Joseph Garruba
28 Winchester Dr.
Hollis, NH 03049
August 17, 2020

To: Members of the Hollis Planning Board

Non-compliances of the proposed development of Tax Map 41 Lots 25, 28 and 44 Revision 2

Figure 1 Developer's slope plan of 3-27-2020 combined with the proposed site plan received July 27, 2020

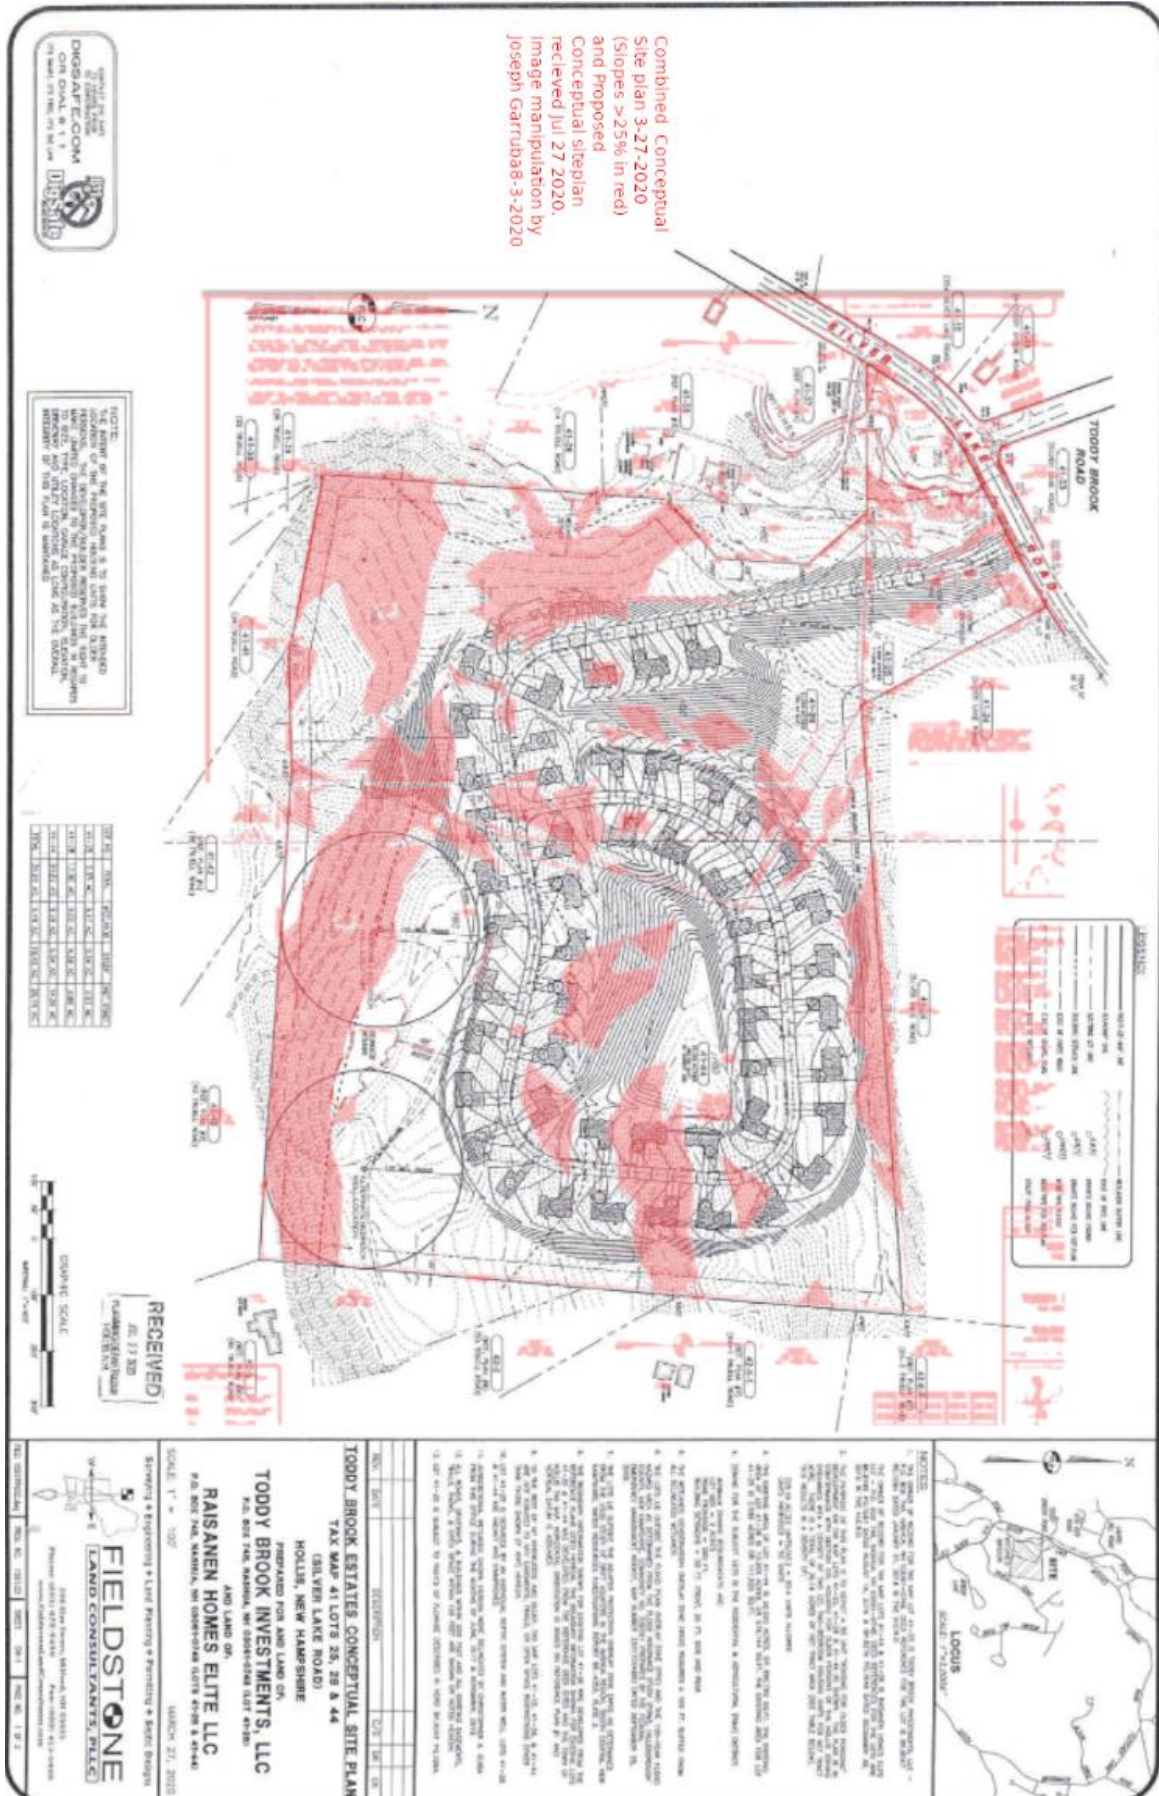
Per the design standards of the Hollis Rural Character preservation ordinance all roadways and driveways must “conform to the natural contours of the land.” Included below is the text of section XV F 4 with a rectangle added for emphasis. The intent is to provide the reader with context. This excerpt has not been selectively edited and the reader is invited to review the Hollis Zoning ordinance in its entirety so as to understand that the full context of the ordinance prohibits road placement that does not conform to the natural contours of the land. Specifically, it can be seen that this is not guidance but a hard requirement.

Considering the requirements of Hollis Zoning ordinance section XV F 4 as cited above. It is clear that the proposal submitted is not in compliance. I request that the planning board make this known to the applicant and require that the applicant submit a proposal that includes a compliant road which conforms to the natural contours of the land. This may require shortening the road, converting the loop to a cul-de-sac design and or reducing the number of units to be developed.

Figure 3 Markup of the developer's alternative conceptual plan submitted on 7/27/2000 with deficient stream crossing

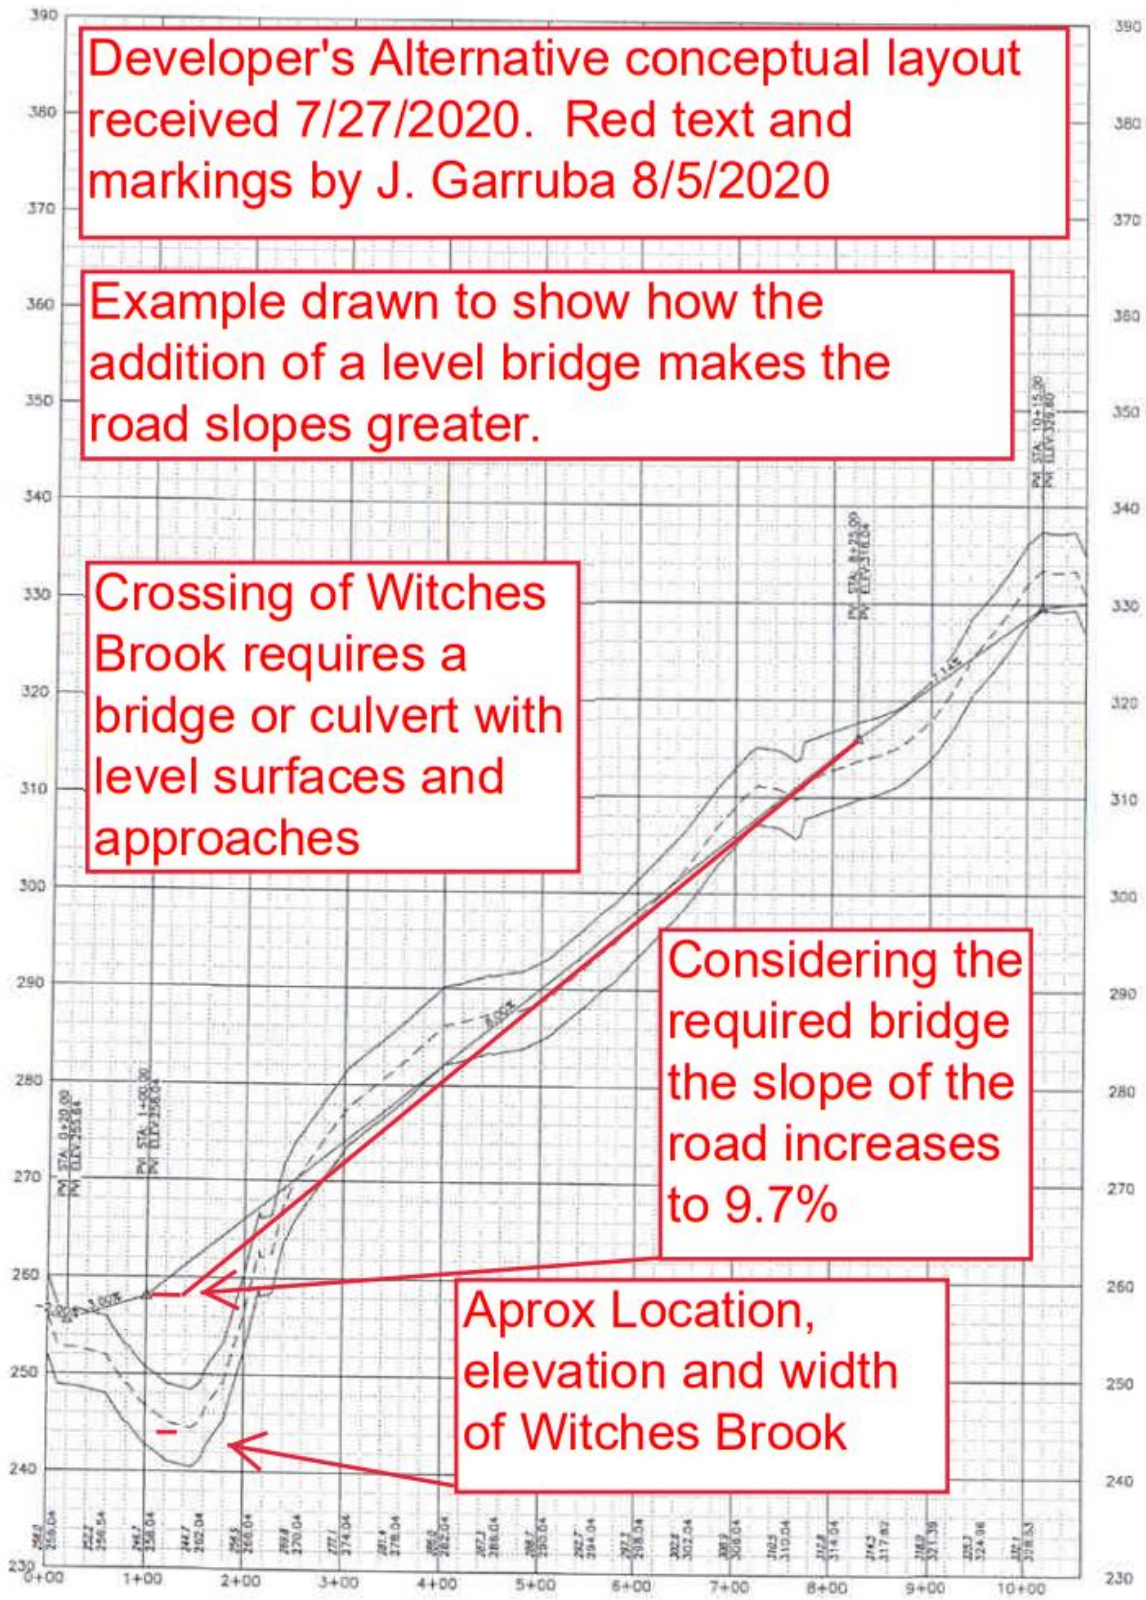
The applicant's alternate conceptual layout shows a roadway crossing Witches' Brook. In order to cross a stream a bridge or a culvert will be required. The road surface above a bridge or culvert will be required to be level due to icing and engineering concerns. For this reason, the submitted profile is not reasonable as the slopes will be required to be steeper than shown to accommodate a level section for the bridge / culvert and its approaches. The following page includes a markup of the developer's alternative conceptual plan submitted on 7/27/2000. The approximate location elevation and width of Witches Brook is included to help visualize the stream crossing and its impact on the proposed roadway. A sample road profile has been drawn simply to illustrate that the added level section makes it more difficult to maintain the maximum grade of the road at 8%. The board should require a realistic proposal of the developer including a bridge if a crossing is proposed in order to evaluate the developer's ability to provide a road that meets Hollis regulations.

An evaluation of the alternate proposal follows, and it will be shown that even without the required bridge, there are many more non-compliances. Based on the submitted materials, it seems that a compliant road to the western side of this parcel is not viable from Silver Lake Road. The planning board should require the developer to prove that a compliant road could be built before considering any requested waivers.

Figure 4 Developer’s conceptual site plan submitted 4-27-2020 showing proposed road crossing natural contours

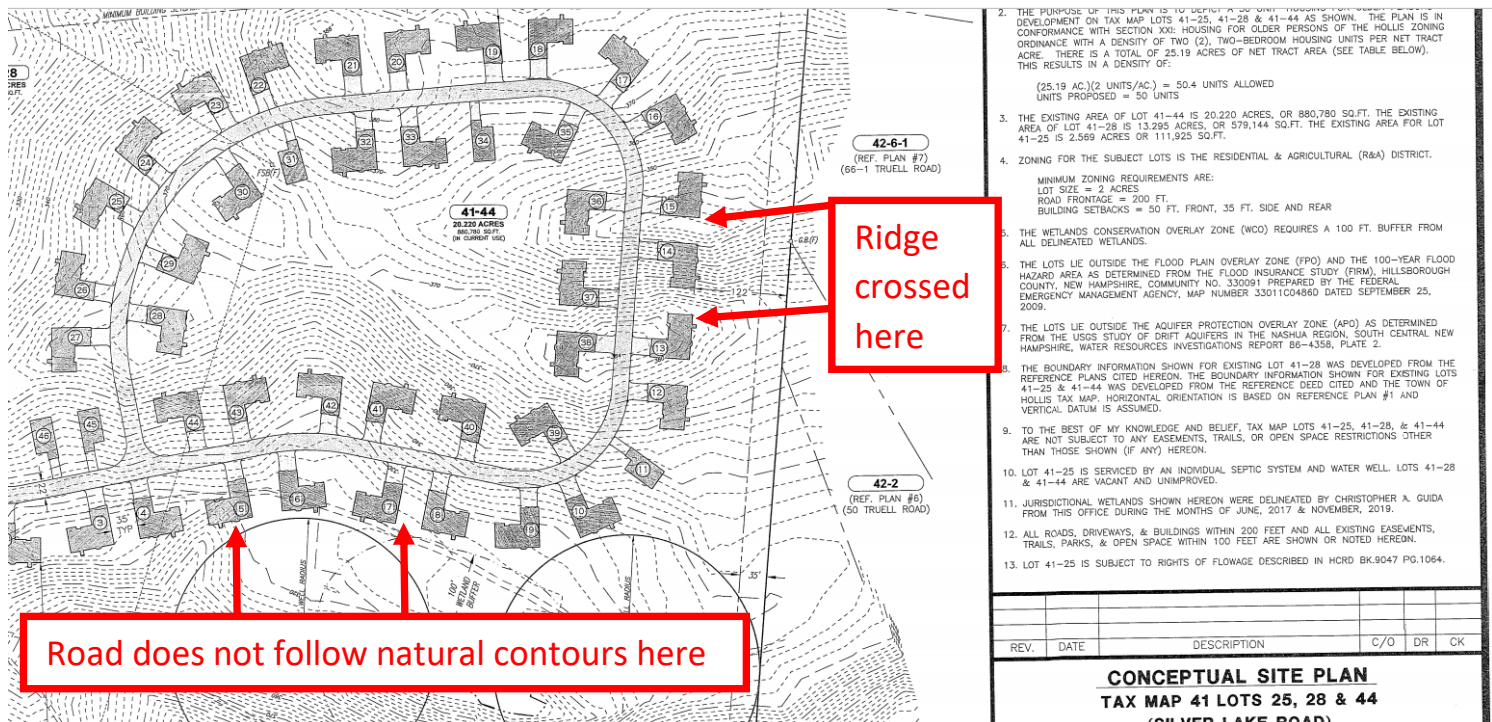
This requirement of the subdivision regulation mirrors the requirement quoted above in section XV F 4 of the Hollis zoning regulations. The actual language states *“To help preserve the natural character of the Hollis landscape, new subdivision streets and driveways shall be logically located with respect to the topography of the site to minimize cuts and fills, and to provide for reasonable grades and safe intersections.”* It can be seen from the developer’s proposal that the loop road is not logically located to follow the natural topography and in 2 locations instead of avoiding natural slopes greater than 25% it actually traverses these areas. Specifically, between buildings 5 and 7, a large fill is required and between buildings 15 and 13 a ridge is completely cut. An image of the developer’s site plan received April 27th is included on the following page with text boxes and arrows added in red to highlight the non-compliant roadway sections.

I am requesting that the planning board require that the developer submit revised plans that satisfy this section of the subdivision regulations by following the natural contour of the land and minimizing cuts and fills. This may require relocating the loop road or changing it to a cul-de-sac design. Due to the slopes on this property the developer may have to remove units from the proposal in order to satisfy this requirement.

Figure 5 Combined Profile from developers conceptual site plan received 7/27/2020

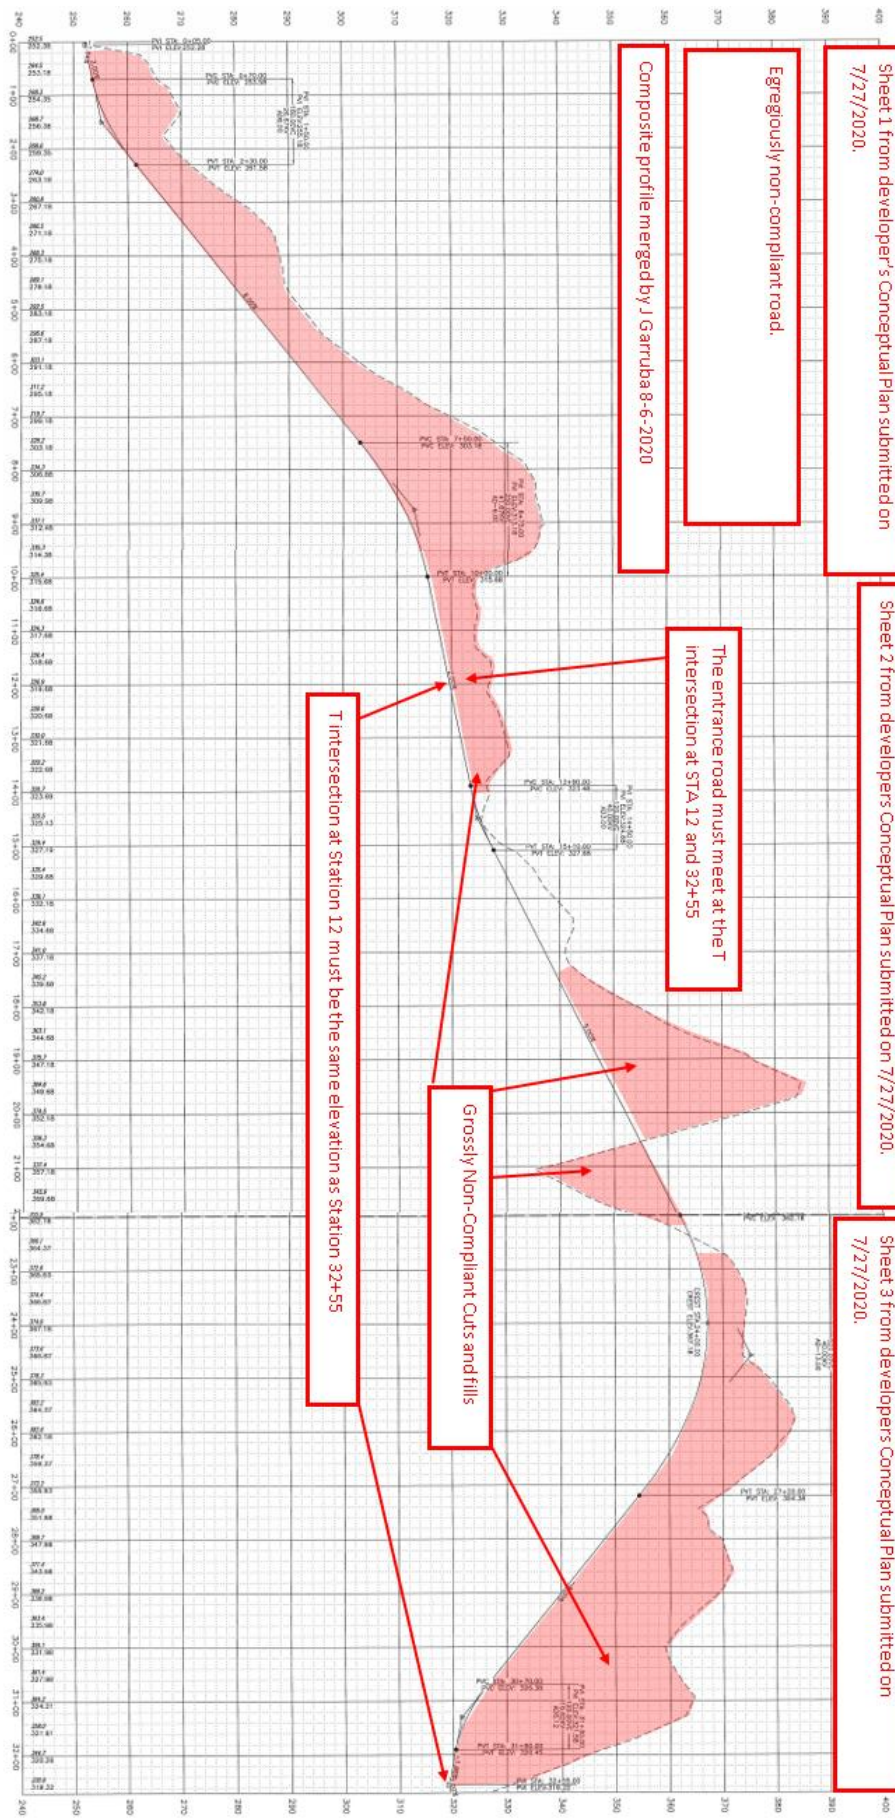
Review of the developer’s proposed conceptual plan road profile shows many egregious non-compliances. On the following page is a composite image of the road profile as provided on 7/27/2020. Sheets 2,3 and 4 have been combined to provide the reader with a continuous view. It can be seen that there are 4 areas where cut or fill is proposed at 4 foot depths for more than 150 feet.

The amount of material removal proposed is astounding. This same developer is presently having difficulty completing a project of much smaller scale in the Keyes Hill development. What could justify granting a waiver of this magnitude? How many cubic yards of earth are proposed to be removed? The amount of noise and truck traffic from an operation of this scale will be tremendous. Will the developer be able to complete this project? They have been waylaid by “unusually hard” rock at the Keys Hill project. Why would we as a town put the abutters of another project through the ordeal that the Keys Hill abutters are suffering through? I am requesting that the planning board not consider a waiver of the road requirements of our subdivision regulations for these reasons. The developer should be required to present a compliant project without waivers.

Figure 6 Number of cuts or fills greater than 4 ft. from Developer's Alternative site plan received 7-27-2020

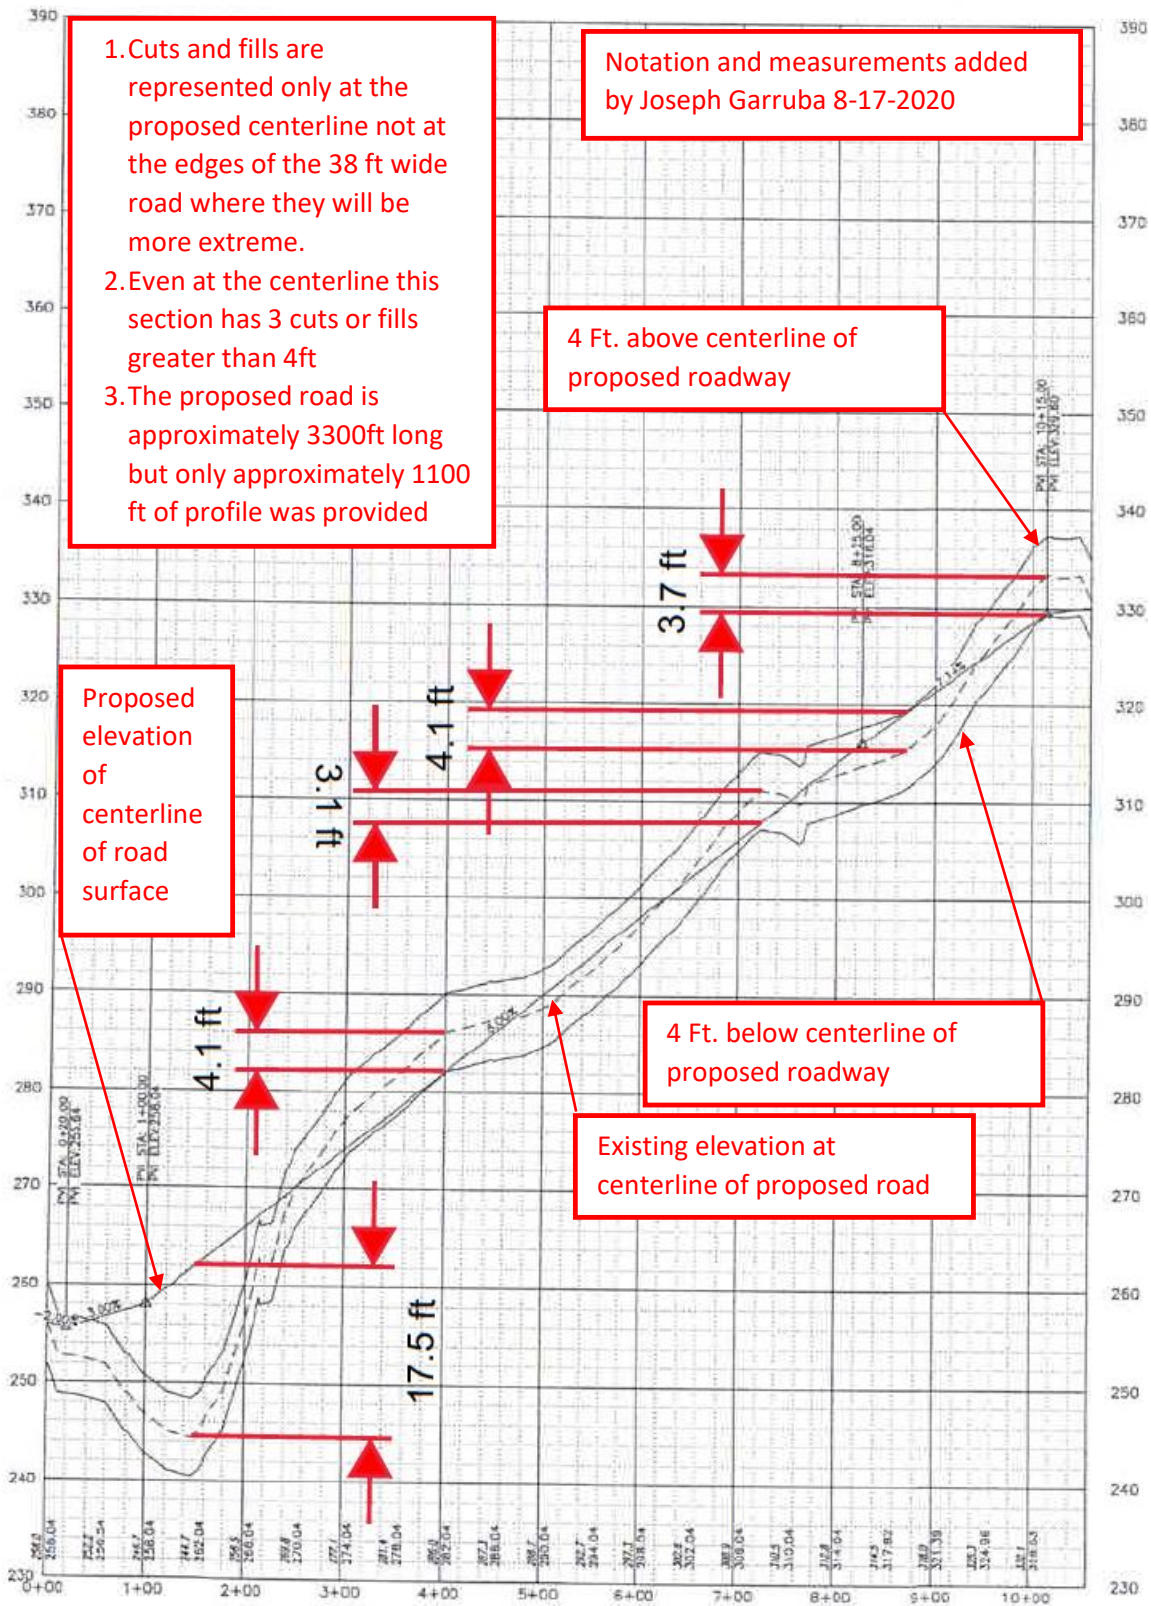
This requirement is separate and distinct from the requirement preceding it in Section IV.7 which allows for a measurement from the centerline only. The fact that centerline is not included in this requirement indicates that it represents the absolute value across the width of the entire roadway. Although they are not labeled, the developer represents only centerline projections in the road profiles provided including on the alternative site plan submitted on 7/27/2020 as follows. This requirement speaks to the absolute value of the cuts or fills which is likely to be greatest at the edges of the road when the roadway follows a contour line as it does between stations 8 and 9. In addition, the proposed road is approx. 3300 ft. yet the developer did not represent even centerline cuts and fills beyond 1100 ft. An omission of approx. 2000 ft. most certainly does not demonstrate compliance. It can be seen that there are 3 cuts or fills from the centerline to the existing grade greater than 4ft in the first 1300 ft section of road depicted. The developer did not identify the lines on the drawing, but verbally indicated that the lines are all referenced from the centerline of the proposed roadway. Our ordinance does not specify the measurement to be made this way. In fact, our ordinance refers to the absolute amount of cut and fill which would need to be measured at the edges of the 38 ft. wide road and shoulder require. If the profile was drawn correctly, the noncompliance’s would be even more evident. On the following page is an image showing the number and size of the cuts and fills at the centerline in only the first 1300 ft. of roadway provided in the developer’s alternative conceptual plan submitted on 7/27/2020. Measurements and comments have been added in red for emphasis.

Considering that the developer was requested to present a proposal that did not require waivers for the construction of the proposed development, it is disappointing to see that the submitted material is both incomplete and non-compliant. The board should require the developer to submit a profile for the entire width of the roadway and required shoulder. Our regulations require a minimum of 38 feet including the shoulder. The access road for 50 units is a roadway, not a common driveway. In either case, the profile needs to be provided to the limits of the shoulder for the entire length of the proposed roadway. If the developer cannot prove a compliant development can be constructed, the planning board should request that the number of units be dramatically reduced before considering a waiver.
